(A) APARTMENT HOUSE ZONE: APPLICATION FOR PERMIT

AP Welch Street, Peaks Island-I
(American Legion)

Subject: Building permit for re-constructing outside rear platform and steps serving as an emergency means of egress from the Post Home on Welch Street, Peaks Island

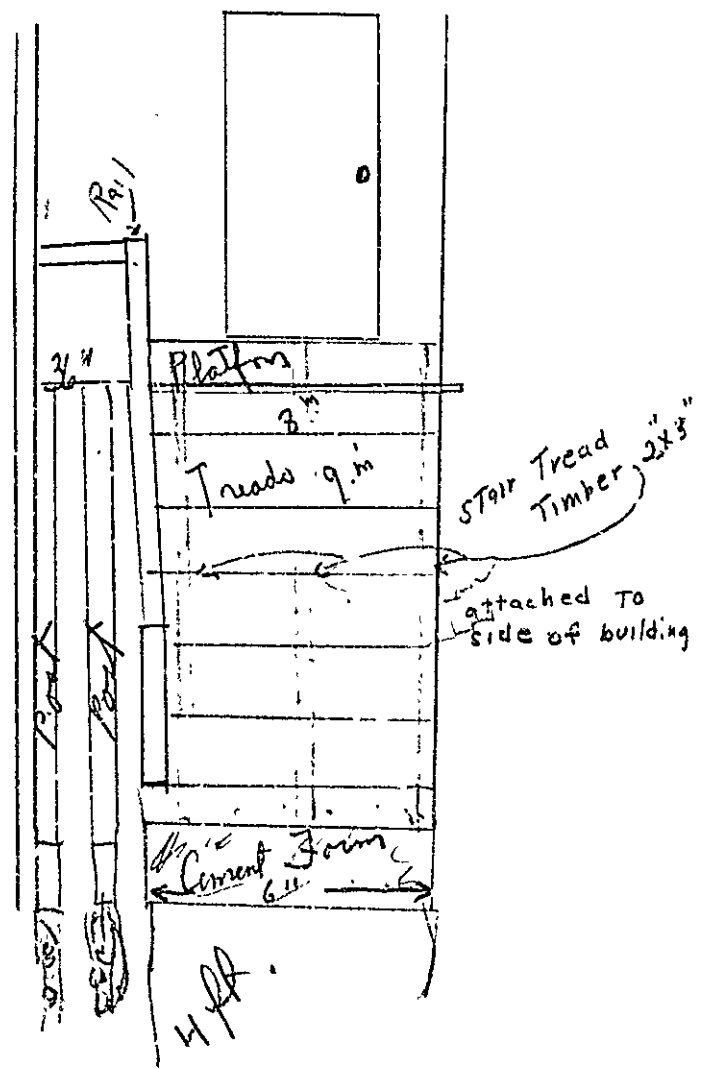
1. The sketch indicates and you will remember that the platform at the top is to be made wide enough so that the railing will be far enough from the doorway to allow the exit door to swing wide open far enough so that the anti-panic bar will not obstruct the width of the doorway. It is possible to make the top platform wider than the stairway, of course, but that proposition would introduce some differences in framing and supports which are not shown on your plan. The least width allowed for the stairway is 36". A handrail is required on both sides of the stairway, full length, and the handrail should not project into the stairway more than 3 1/2".

2. The sketch shows the risers to be 8" and the treads 9". Note that the least allowable width of tread is 9" and especially that this width is to be measured from riser to riser not from riser to nosing, the sketch showing the nosing to project one inch beyond the riser. The Building Code allows the risers to be as much as 8 1/2", but not more. You may find it of advantage to make the risers a little more than 8", but both height of risers and width of treads should be uniform.

3. The level of the new platform at the top of the stairs should be approximately the same level as the hallway inside leading to the exit door with the normal threshold only allowed, this to avoid a stepdown under the outward swing of the door.

4. If there is any object, it is likely that you could eliminate the post and concrete pier shown about half way down the stair, since the stair stringers will not have a long span. If this post were used to be of real service, you would also have to use a beam across under the stair stringers and support it upon the building.

5. Considerable care should be taken where the new upper platform is to be supported upon the building, the weather boarding removed, the frame of the platform supported on the frame of the building, the weather boarding replaced and suitably "flushed" to give long life.

6. The concrete piers are required to extend at least 6" above the surface of the ground as well as 6" below.

P. S. Treads of stairs are required to be anti-slip.

ELEVATION PLAN

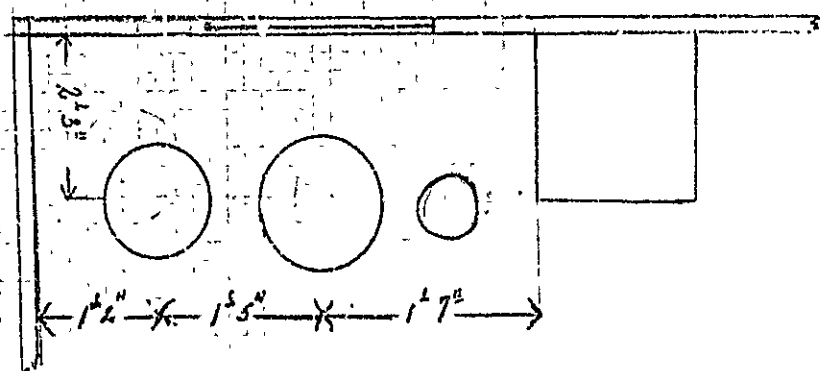
Mr. M. W. Jones has applied for a building permit, as he is required by law to do, to cover installation of an oil burning hot water heater (Perfection Heater No. 312) in the Legion Post home on Kaich Street, Peaks Island, but I am unable to issue the permit for this heater because it does not appear in the list of domestic hot water heaters approved by the Chief of the Fire Department.

That is not to say that the heater could not be approved as it is quite possible that the reason it does not appear in the list is that it has never been submitted to the Chief of the Fire Department. I suggest that you submit to Chief Subern a diagram, plan or other illustration of this heater seeking his approval so that if he is able to approve it, the heater may be added to the list and the permit issued.

Under authority of approval of the burner as far as it is placed in accordance as Inspector of Buildings, I shall have to insist that the tank or oil container be rigidly supported upon the same standard or base as the burner itself as distinguished from the usual range burner type where the oil supply container is supported usually on a separate standard entirely independent of the range itself as far as supports are concerned.
